JOINT REGIONAL PLANNING PANEL REPORT

15 MAY 2014

Development Application No.	➤ D/2013/406
Address	➤ 100-102 Elliott Street, BALMAIN NSW 2041
Description of Development	➤ Demolition of existing structures, construction of a mixed use development including 8 buildings with ground floor commercial (including 19 serviced apartments and gymnasium) / retail uses, 104 residential units above, basement parking for 251 vehicles and associated works including bulk earthworks, tree removal, landscaping, signage and remediation.
Date of Receipt	➤ 18 September 2013
Value of Works	➤ \$54,916,484
Applicant's Details	➤ Roche Group Pty Ltd C/- Wes Van Der Gardner PO BOX 325 DOUBLE BAY NSW 1360
Owner's Details	➤ Roche Group Pty Ltd PO BOX 325 DOUBLE BAY NSW 1360
Notification Dates	➤ First Round: 10/10/2013 to 8/11/2013 Second Round: 25/2/2014 to 26/3/2014
Number of Submissions	➤ 105
Building Classification	➤ Classes 2, 3, 5/6 & 7a
Integrated Development	➤ Yes

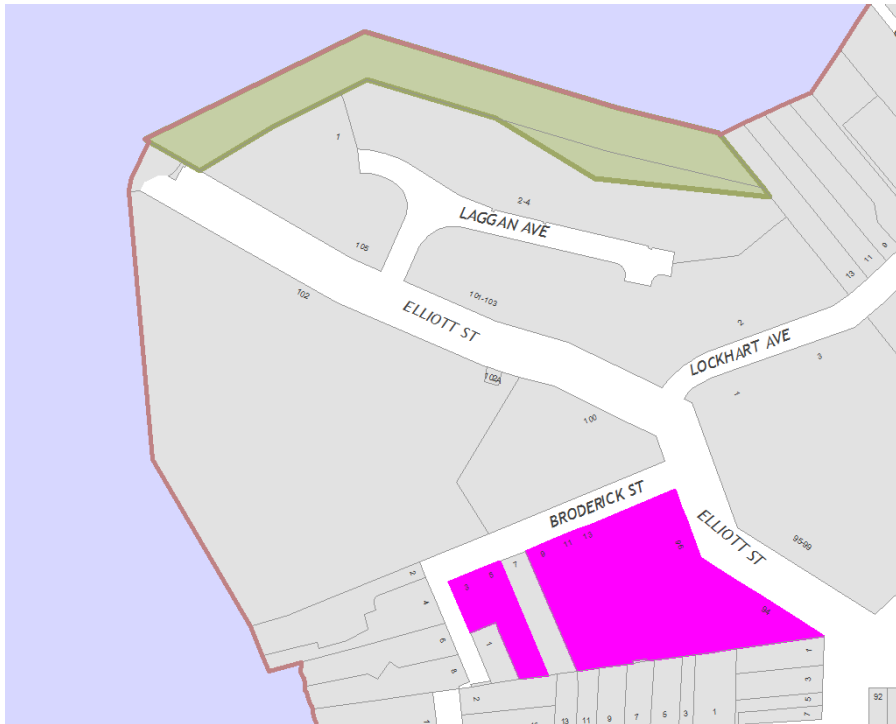
The main area of concern with regard to privacy is the potential for overlooking of 2 Broderick Street from building C4 which faces the foreshore. Appropriate privacy measures have been utilised for the majority of building C4 which includes fixed louvers to prevent overlooking however there are some areas of concern in relation to privacy including windows and balconies on the southern elevation therefore a condition is recommended to be imposed which will require the LV1 adjustable louvers of the bedrooms of units C4.002; C4.102; C4.103; C4.202 and C4.203 being changed to LV2 fixed louvers. The balconies of C4.102 and C4.202 shall have LV2 fixed louvers installed on their southern elevation to protect the privacy of 2 and 4 Broderick Street. The fixed louvers on the eastern elevation of these balconies is to be removed and the glazing on A2.109 to the western elevation of the kitchen is to be replaced with fixed obscure glazing.

It is also recommended that a condition be imposed requiring a new timber fence to erected between the boundary of the development and 2 Broderick Street to replace the existing chainwire fence given that a lot of the existing vegetation which provides screening will be removed.

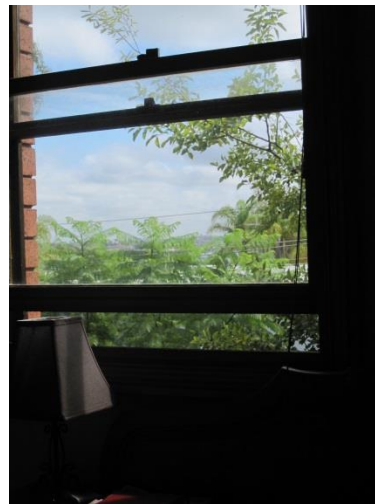
The views from the balcony and bedroom are restricted, filtered and distant views. It is recommended that the uppermost floor of Building A2 opposite the site be slightly reduced in height which may still allow for some water glimpses across the site. The view loss is considered minor/moderate in this case, given the limited views currently available.
